# **28F400BV/CV/CE 28F004BV/BE SPECIFICATION UPDATE**

Release Date: February 1997

Order Number: 297595-013

**Timing Waveform for WE#-Controlled Writes**

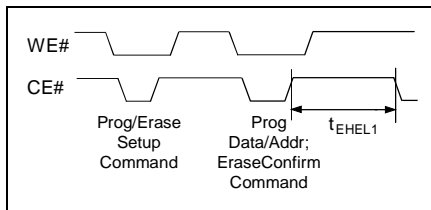
**WORKAROUND:**
**A.  $t_{WHEH}$ - CE# Timing Erratum**

Due to a logic timing problem, new timing restrictions may be necessary between the WE# and CE# signals during write operations. The timing waveforms and specifications are shown below:

Symbol	Parameter	Datasheet		Errata		Units
		Min	Max	Min	Max	
$t_{WHEH}$	CE# Hold Time from WE# High	0	no spec	0	5	ns
$t_{WHEL1}$	CE# Pulse Width High from WE# High	no spec	no spec	110		ns

Basically, these new errata specifications for WE#-controlled writes require the system timing to:

1. Take CE# to logic high no earlier than WE# goes high and no later than 5 ns after WE# goes high.
2. Hold CE# high for at least 110 ns, starting from the time WE# goes high.

These timing specifications must be met for proper operation of the device. The flash memory chip select must go inactive within 5 ns of a program/erase operation and remain inactive for a period of 110 ns before going active again. Consider the following options for meeting the  $t_{\text{WHEL1}}$  or  $t_{\text{EHEL1}}$  requirement:

1. Follow a program/erase two-write sequence with an access to another memory so as not to decode the flash memory chip select for the required period of time.
2. Insert one or more no-op commands following a program/erase two-write sequence, again to ensure the flash memory chip select is disabled for the required period of time.

Depending on your system implementation, the  $t_{\text{WHEH}}$  requirement may require additional logic to ensure the required  $t_{\text{WHEH}}$  timing. Evaluate your system timing to ensure the new write requirements can be met. This erratum has been fixed in B-step material.
